9.0 TECHNICAL SPECIFICATIONS

Calvert Cliffs 1 Cycle 8
 Technical Specification Changes
 Excluding HPSI Flow Changes

Calvert Cliffs 1 Cycle 8
 Technical Specification Changes
 Concerning HPSI Flow

Figure 3.2-4
DNB Axial Flux Offset Control Limits

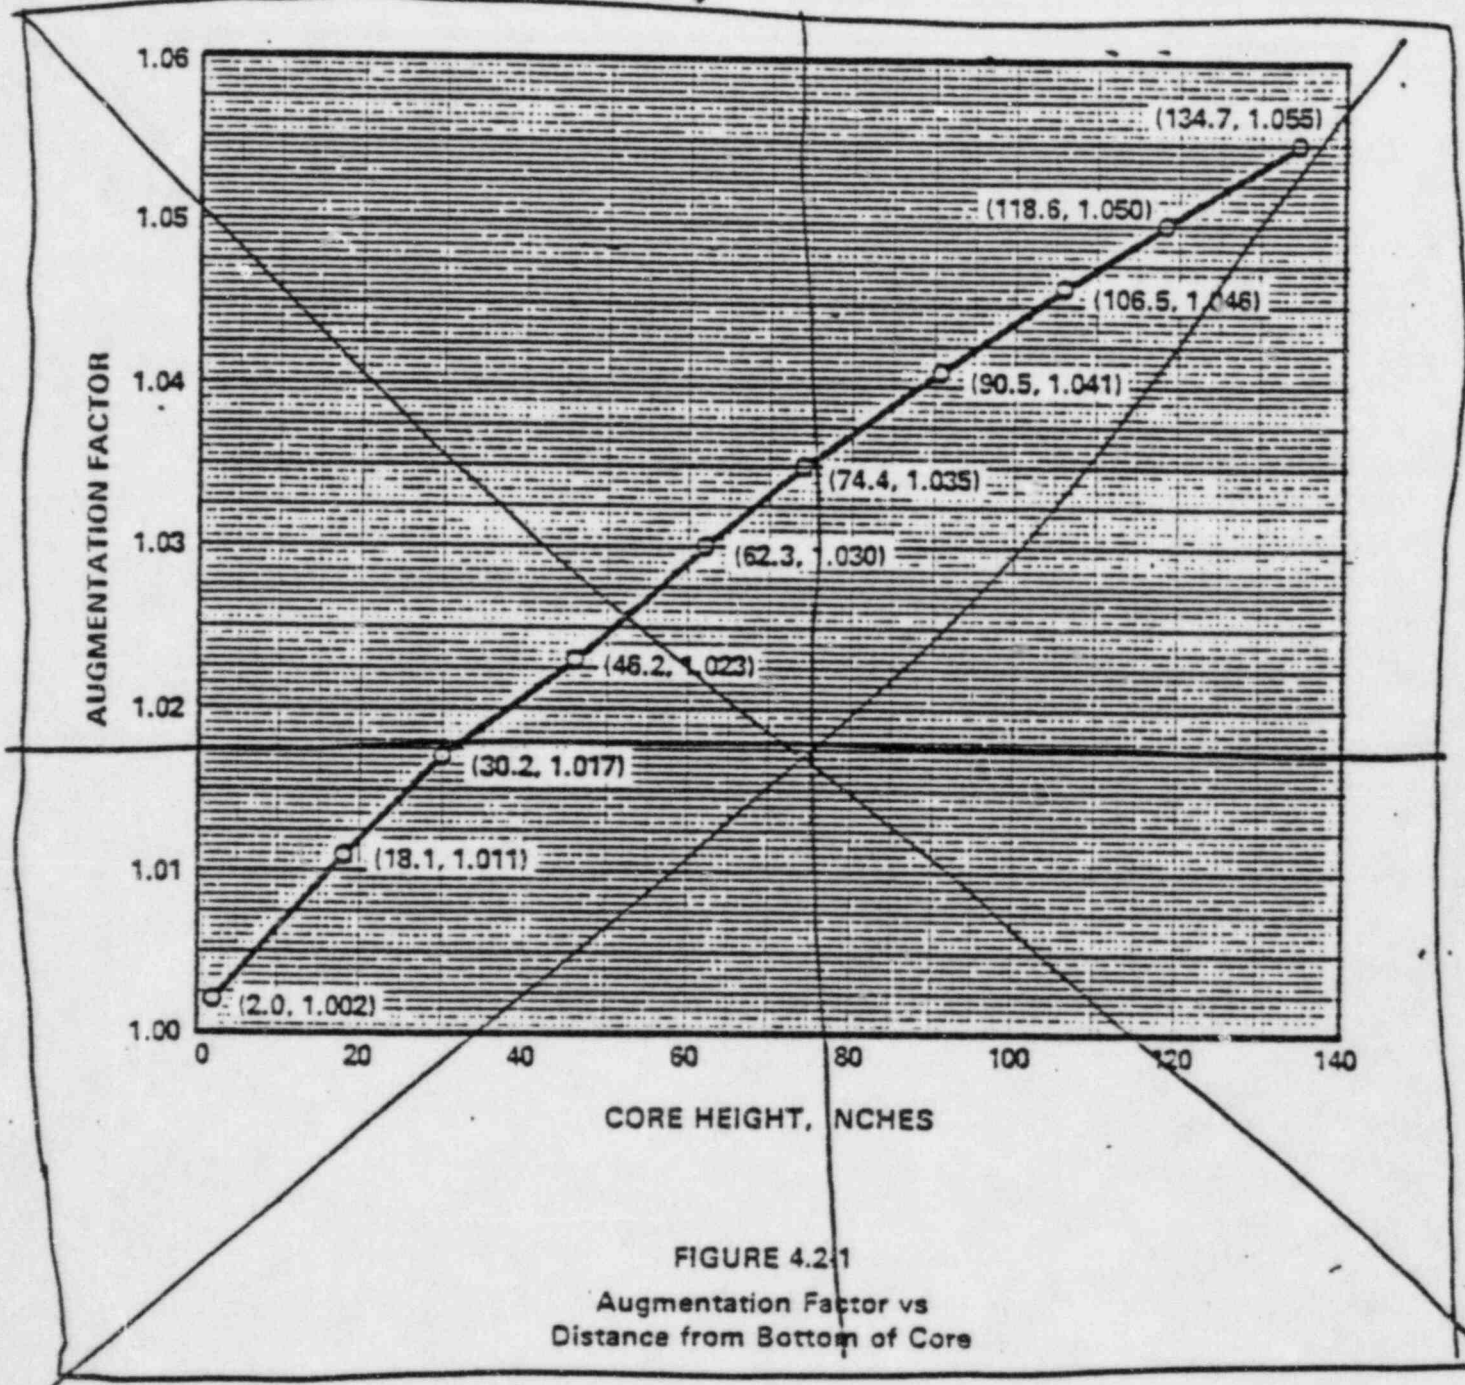
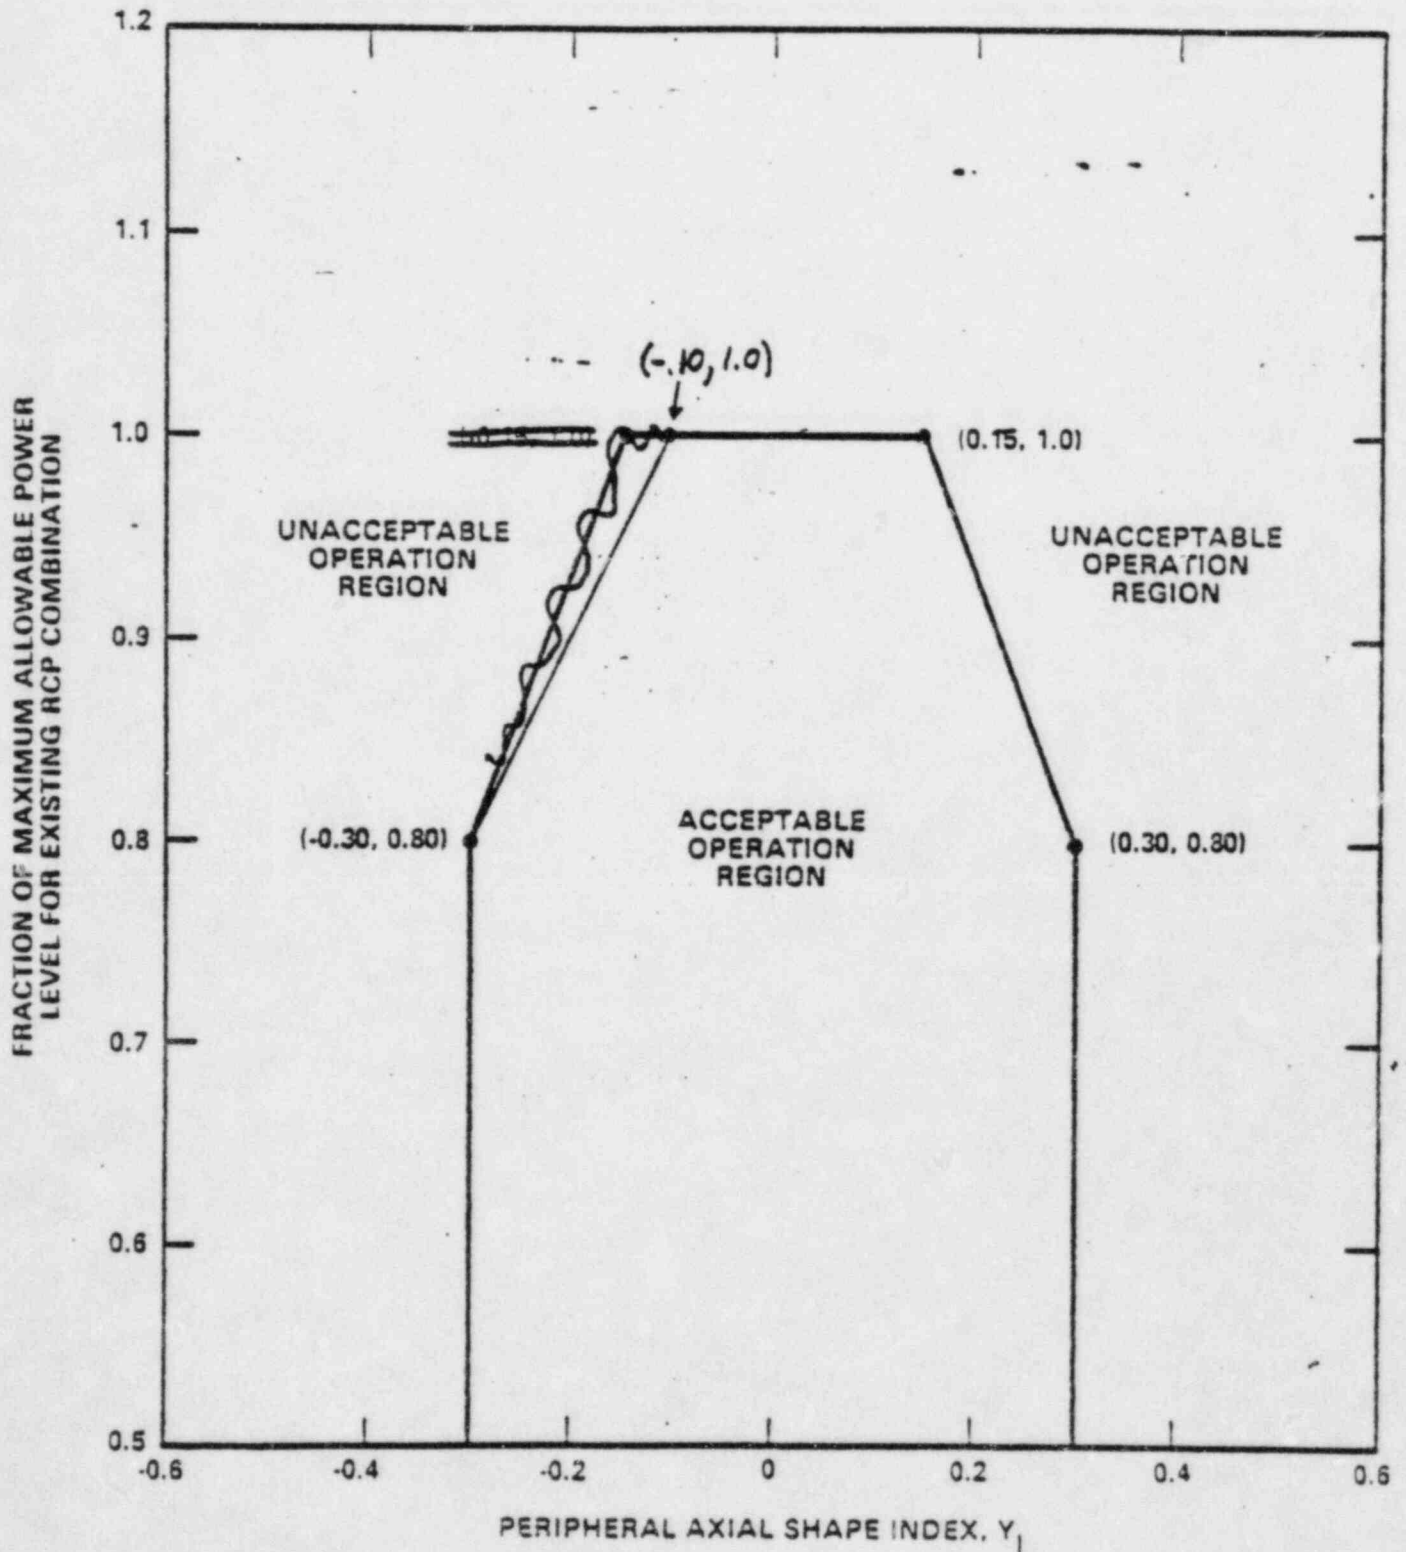
<u>Tech. Spec. No. and Page</u>	<u>Action</u>	<u>Explanation</u>	<u>Support</u>
B 3/4.2.5 page B 3/4 2-2	Insert the additional text concerning limiting criteria on the DNB LCO, as indicated	The BASES section for the DNB LCO is being expanded to more clearly define all of the criteria which are used to establish the Tech. Spec. values.	The text is merely updating the BASES to describe what has been standard practice.
B 3/4.7.1.1 page B 3/4 7-1	Modify the text concerning Mode 3 operation, as indicated	See change for Tech. Spec. 3/4.7.1.	See change for Tech. Spec. 3/4.7.1

← INSERT NEW PARAGRAPH (A) HERE (A) IS ON NEXT PAGE

In addition to the DNB criteria, there are two other criteria which set the specification in Figure 3.2-4. The second criteria is to ensure that the existing core power distribution at full power is less severe than the power distribution factored into the small-break LOCA analysis. This results in a limitation on the allowed negative AXIAL SHAPE INDEX value at full power. The third criteria is to maintain limitations on peak linear heat rate at low power levels resulting from Anticipated Operational Occurrences (AOOs). Figure 3.2-4 is used to assure the LHR criteria for this condition because the linear heat rate LCO, for both ex-core and in-core monitoring, is set to maintain only the LOCA kw/ft requirements which are limiting at high power levels. At reduced power levels, the kw/ft requirements of certain AOOs (e.g., CEA withdrawal), tend to become more limiting than that for LOCA.
